DEVELOPMENT REVIEW BOARD MEETING

2. **Res. No. 438 Frog Pond Ridgecrest Subdivision.** The applicant is requesting approval of Annexation to the City of Wilsonville and Rezoning of approximately 9.00 acres, a Stage 1 Preliminary Plan, Stage 2 Final Plan, Site Design Review of parks and open space, Tentative Subdivision Plat, Type C Tree Removal Plan, Middle Housing Land Division, and Waivers for a 28-lot residential subdivision.

DB24-0008 Frog Pond Ridgecrest Subdivision

Exhibit A1
Staff Report
Wilsonville Planning Division
Frog Pond Ridgecrest 28-Lot Subdivision
Development Review Board Panel 'A'
Quasi-Judicial Public Hearing

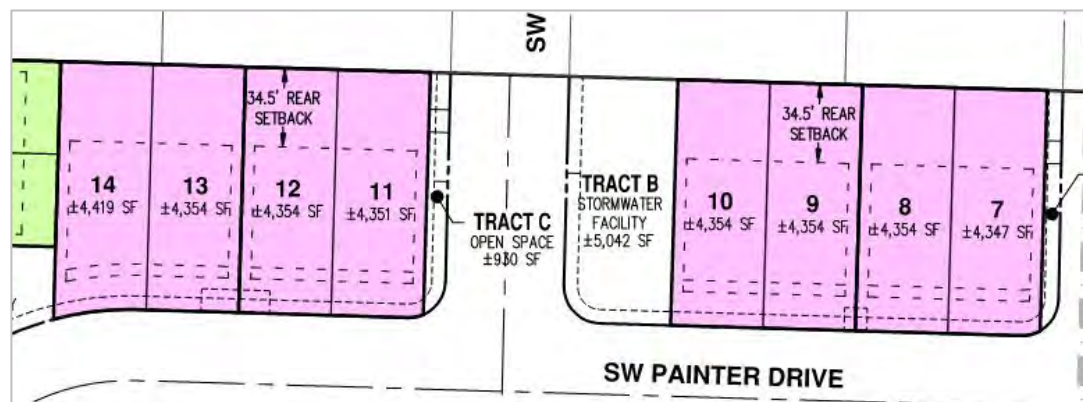
- I2.** Pursuant to Subsection 4.118 (.03) A. waivers must implement or better implement the purpose and objectives listed in this subsection. Per the applicant's Code response narrative, Lots 4-8 and 16-23 "are increased in size because of the necessary placement of streets throughout the development". The layout of streets within the subdivision is dictated by the location of the street network in previously-approved subdivisions to the west, east, and south, and is an allowed variation from the Street Demonstration Plan (Figure 18) as discussed elsewhere in this report (see Finding D11). This street network dictates the location and dimension of blocks within the proposed subdivision, which in turn, and when combined with minimum density requirements for R-7 Sub-district 4, determines to a large extent the size and configuration of parent lots within the subdivision. Thus, the parent lots are larger than the required 6,000-square-foot minimum and the resulting middle housing land division units also are larger than the allowed maximum lot size of 3,600 square feet.

As illustrated in the example below, the applicant proposes to increase the rear setbacks of the affected middle housing land division units from 15 feet to 21 feet (Units 30-35), 23 feet (Units 36-39 and 42-45), and 34.5 feet (Units 7-14), to maintain the same building envelope as lots that comply with the maximum lot size. In addition, lot coverage waivers have not been requested for these lots. A condition of approval requires that the proposed rear setbacks are recorded as a note on the final plat for the subdivision.

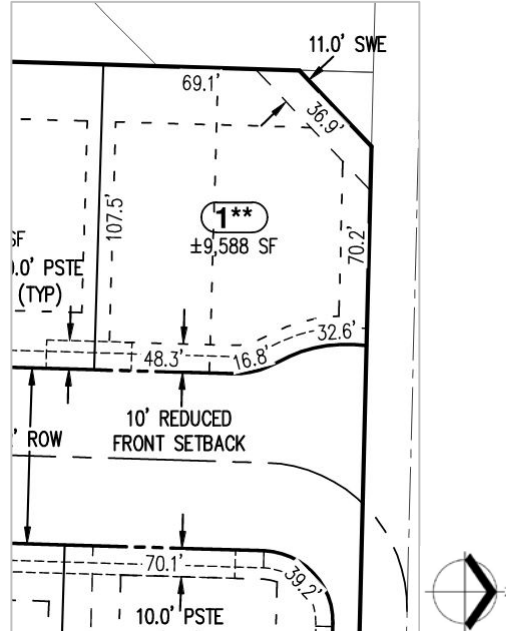
- I5. Subsection 4.118 (.03) A. 3. allows the Development Review Board to waive yard requirements based on findings of fact supported by the record. The applicant requests a waiver to reduce the front yard setback from 20 feet to 10 feet for Lot 1 in R-10 Sub-district 7 (a 50% reduction) and from 15 feet to 10 feet for Lot 19 in R-7 Sub-district 4 (a 33% reduction).

As shown in the illustration below, the difficulty to meet the setback standards of Section 4.127 related to Lot 1 arises from the placement of the existing SW Frog Pond Lane “knuckle” right-of-way and the location of the Boeckman Creek Trail at the northwest corner of the lot, which was established in the previously approved Frog Pond Terrace subdivision. Per the applicant’s narrative Code response, retaining the standard front setback on this lot will require either a very shallow custom home on the northern middle housing unit or elimination of the dwelling unit (one (1) unit in a two-unit cluster). While the home would have a narrower front setback, it would remain generally even with the adjacent home (on the south portion of Lot 1) due to the proximity of the SW Frog Pond Lane eyebrow curve.

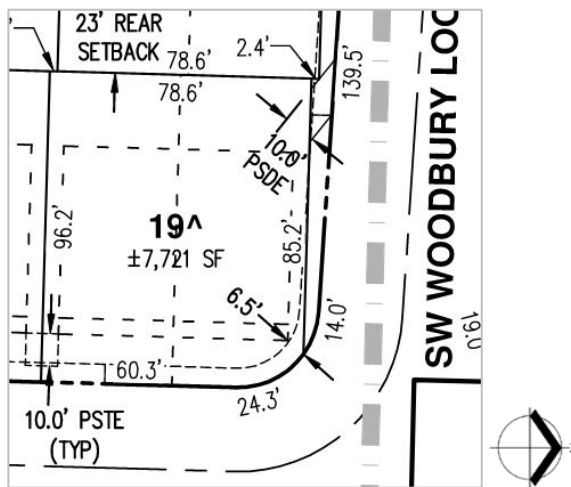
Related to Lot 19, as shown below, the northern middle housing land division unit on this lot experiences similar constraints to Lot 1. In order to accommodate right-of-way width to provide two-way traffic and looped utilities through the SW Woodbury Loop right-of-way adjacent to Tax Lot 1101, the front setback of Lot 19 must be adjusted. Per the applicant’s Code response narrative, the change will permit the northern home on Lot 19 (middle

housing Unit 36) to remain similarly sized, scaled, and positioned in relation to the southern home on Lot 19 (middle housing Unit 37). The front setback on Unit 37 would be forced to follow the curve of the SW Woodbury Loop right-of-way without the requested waiver. This would, in turn, force the home on this lot to be pulled back from the street, narrowing the home needlessly and creating a difficult home to build and live in. The garage location and setback will be unaffected by the requested waiver and is still planned to be located further south of the problematic northeast lot corner.

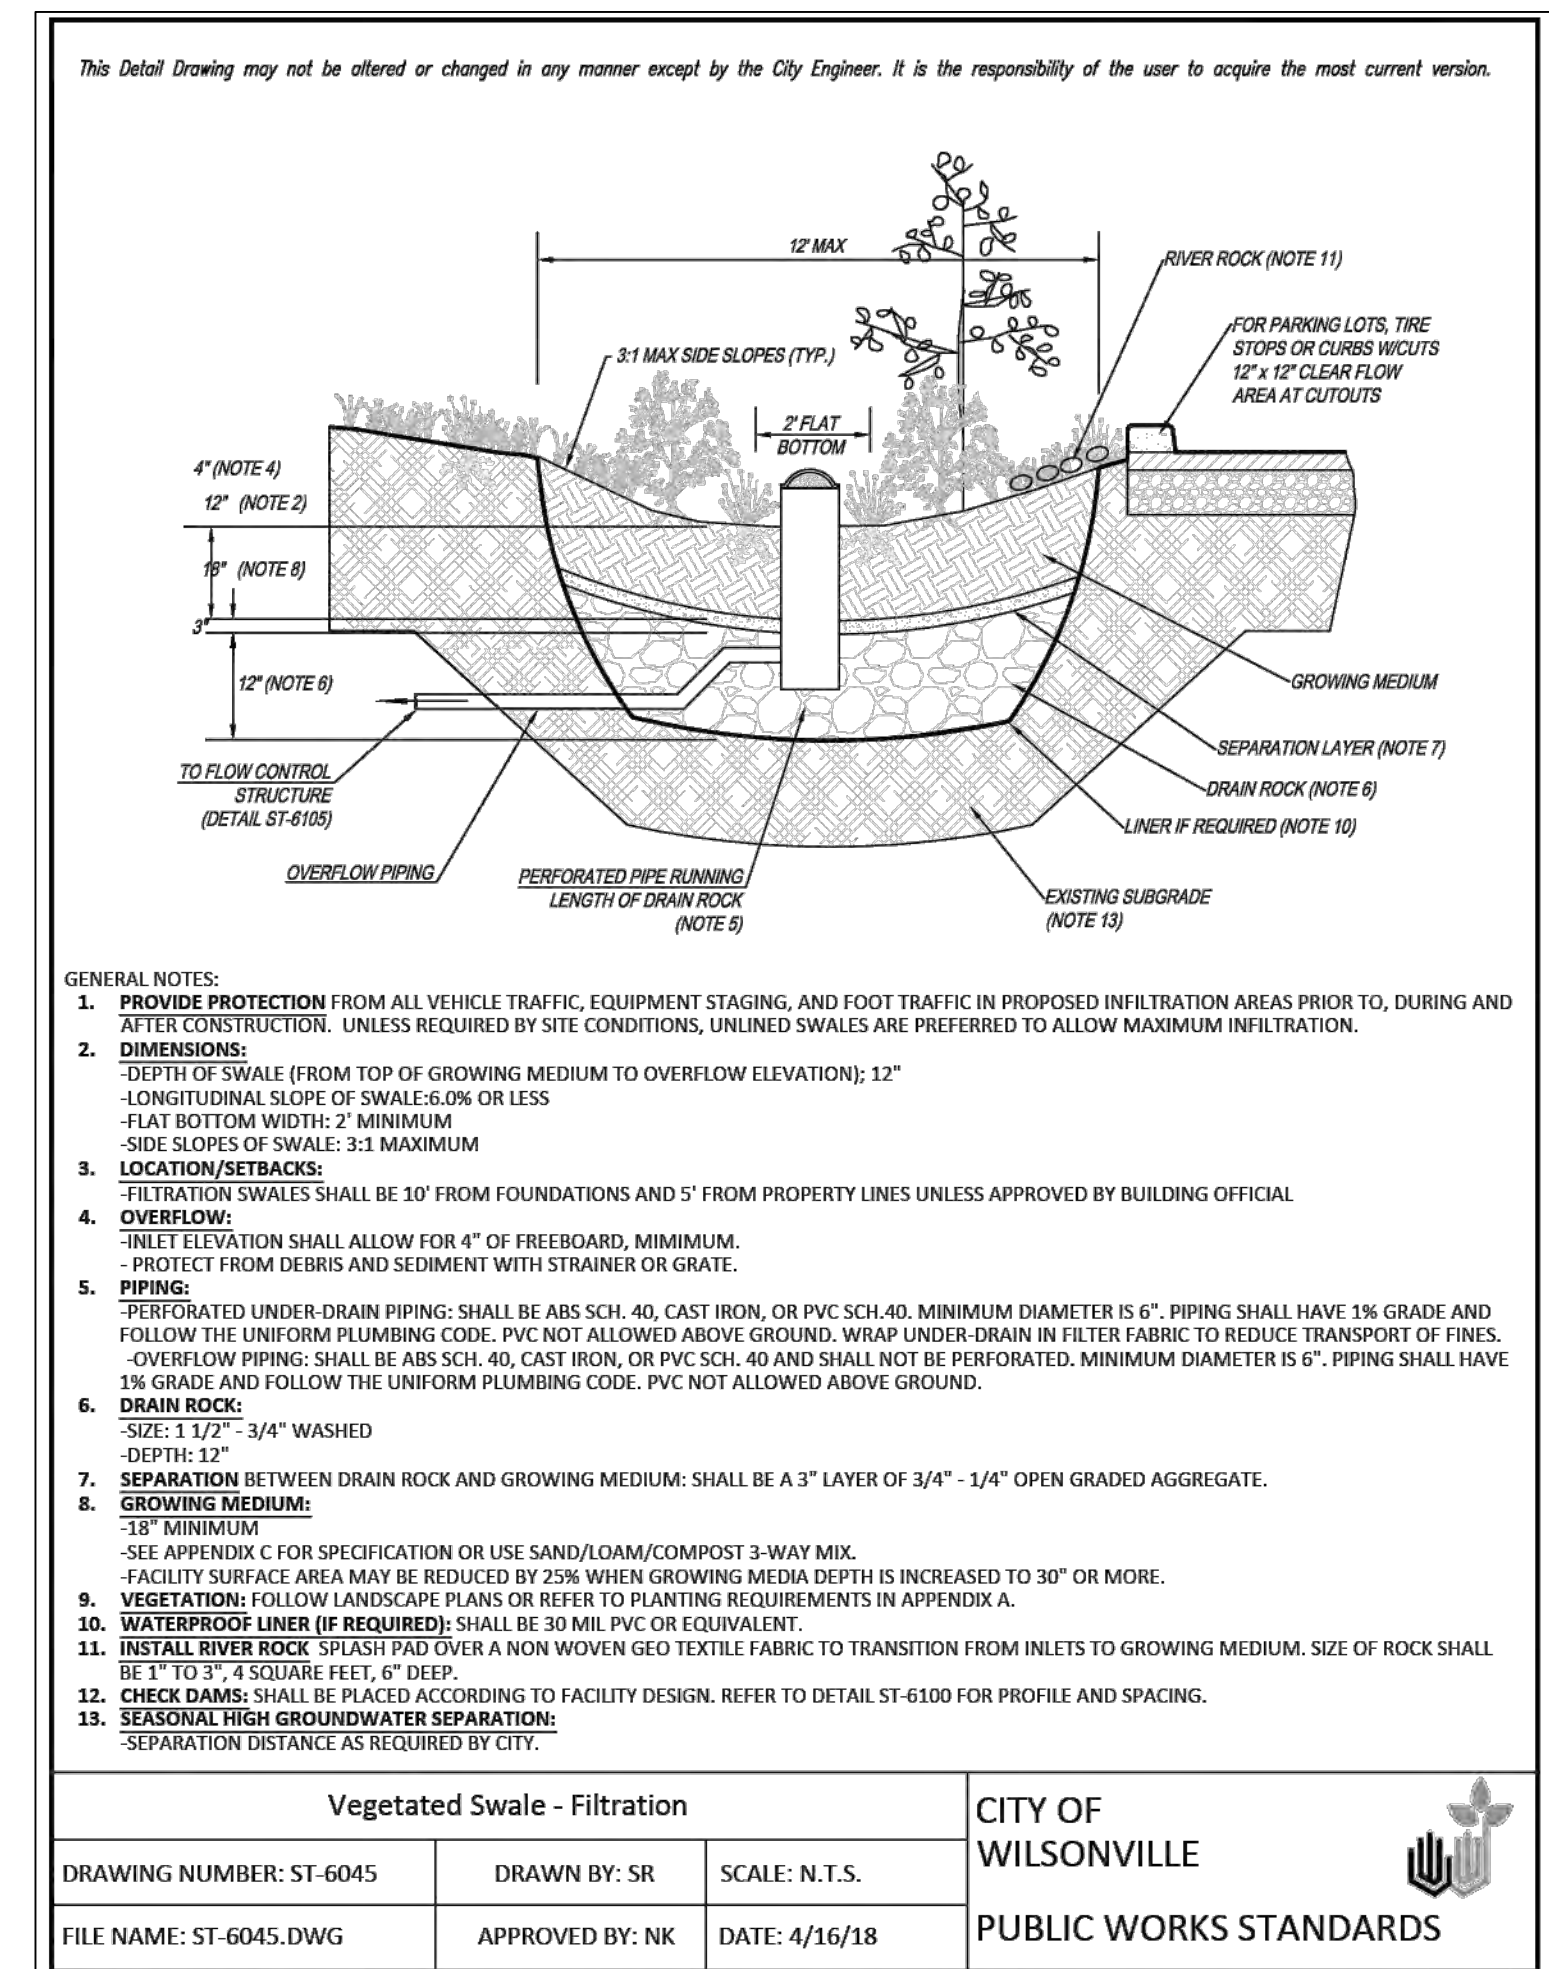
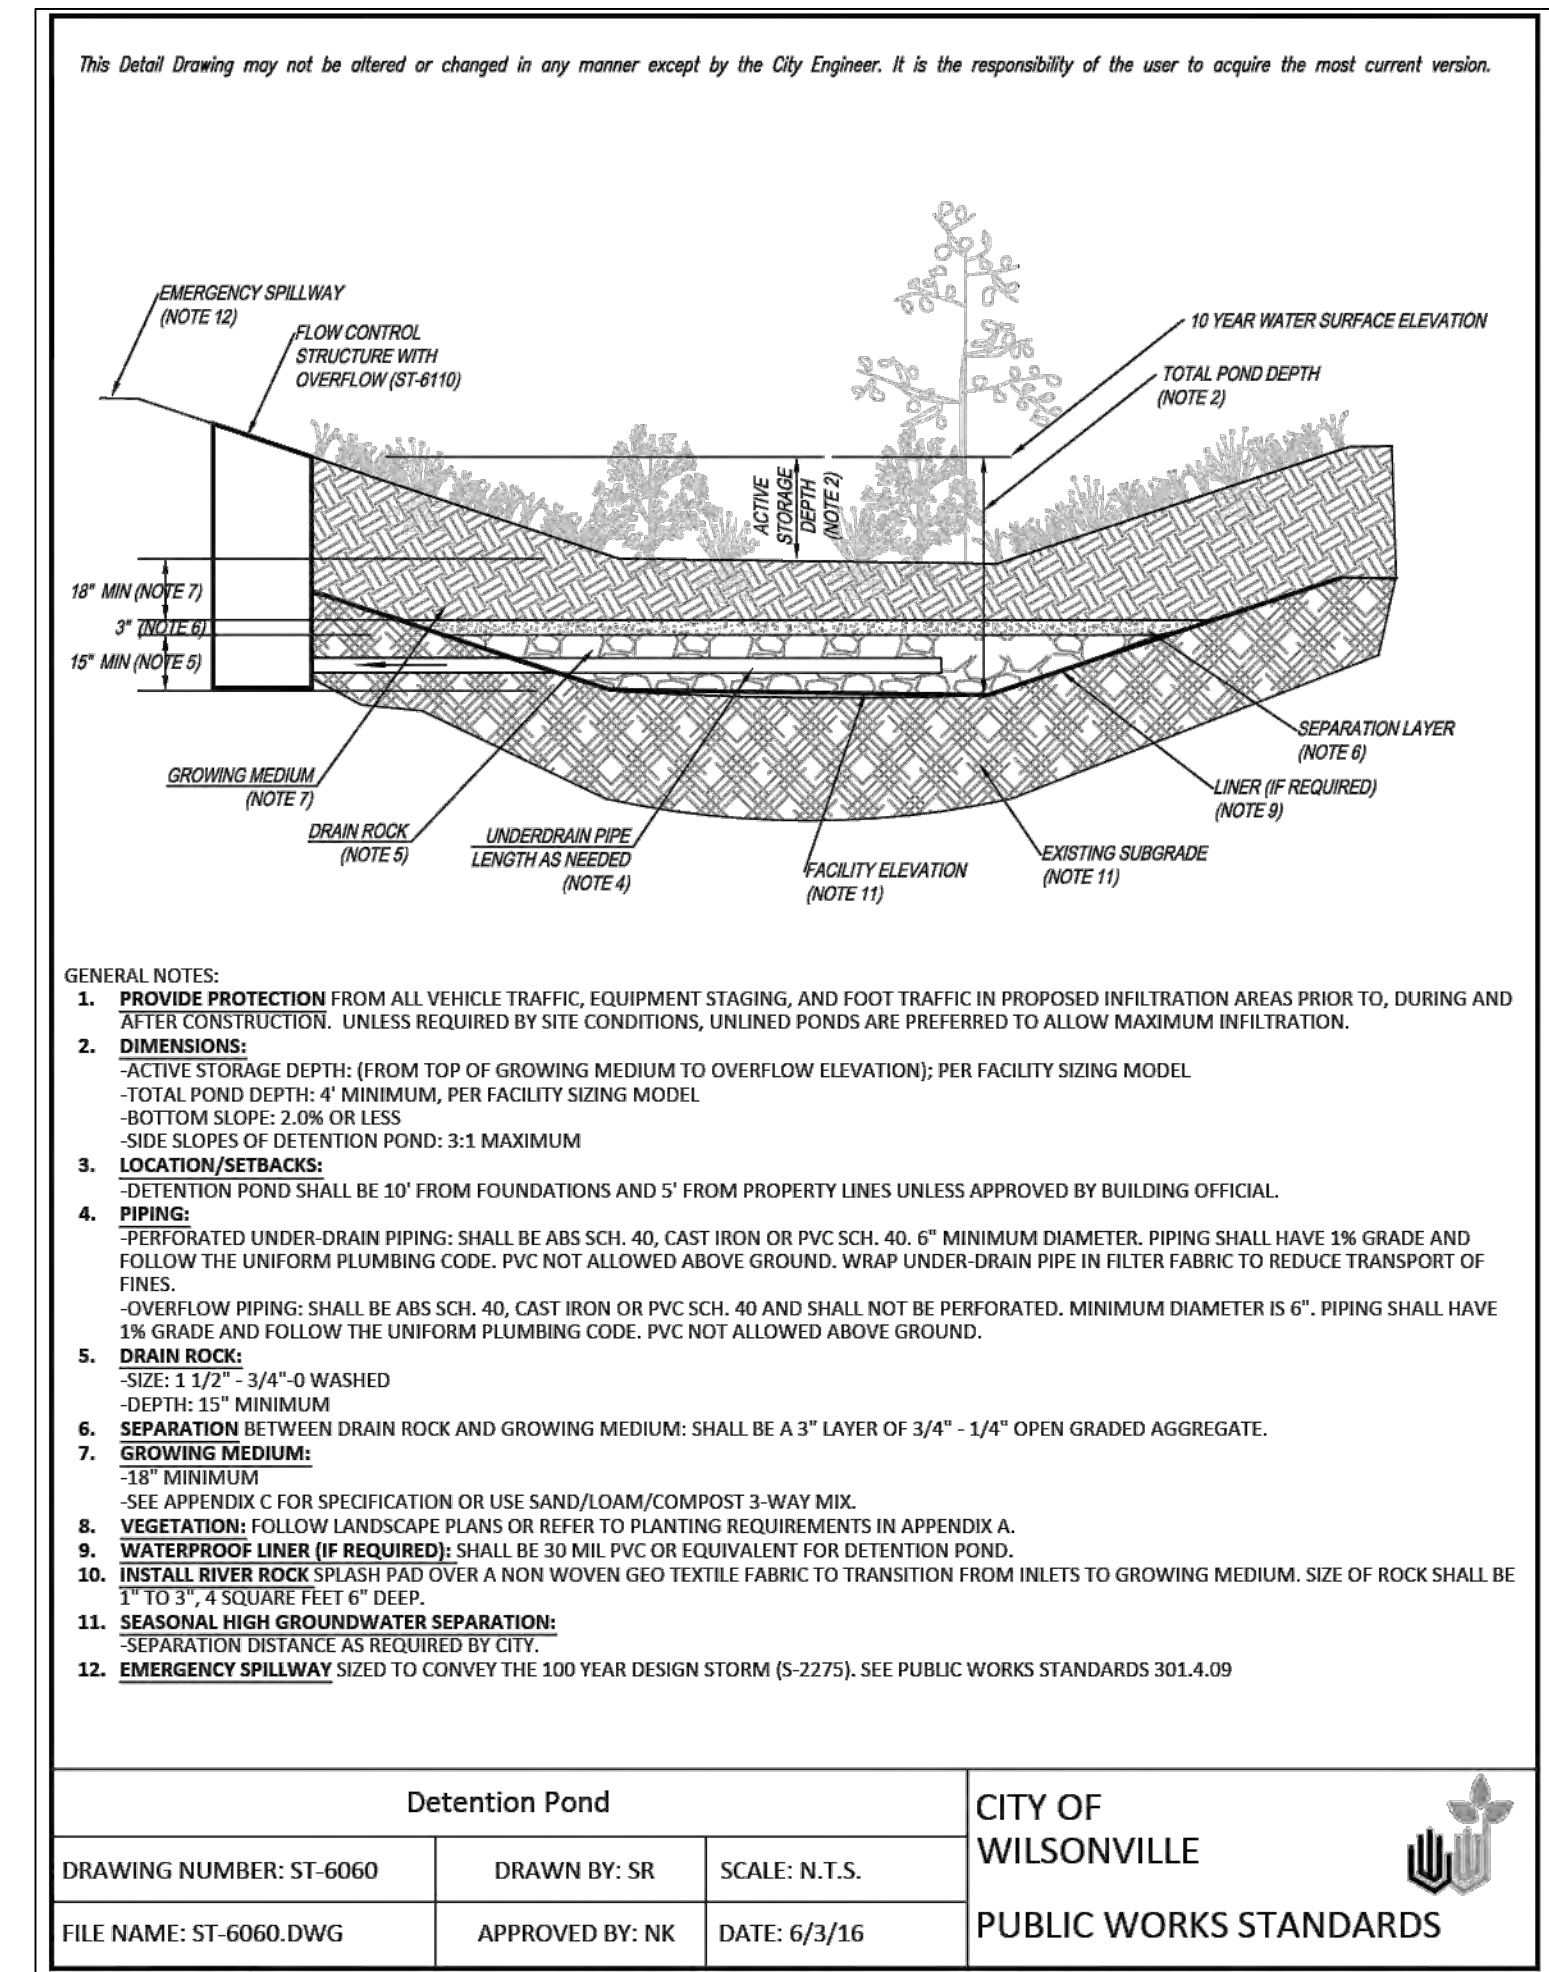
G22. The applicant proposes planting 76 street trees and 141 trees in the open space areas, totaling 217 mitigation trees. Staff notes that 216, not 217 trees are shown on the revised landscape plan (Exhibit B4), specifically 75, not 76, cascara trees. Therefore, the total number of mitigation trees is one (1) fewer than the one-to-one ratio of 217 trees required by this subsection. A Condition of Approval requires planting of one (1) additional tree to ensure the requirement is met. Exhibit B4 shows all trees proposed for planting as mitigation as 2-inch caliper, or the equivalent 6- to 8-foot for conifer trees.

Attachments: Updated Preliminary Landscape Plan
Replacement Tree Planting Landscaping Memo
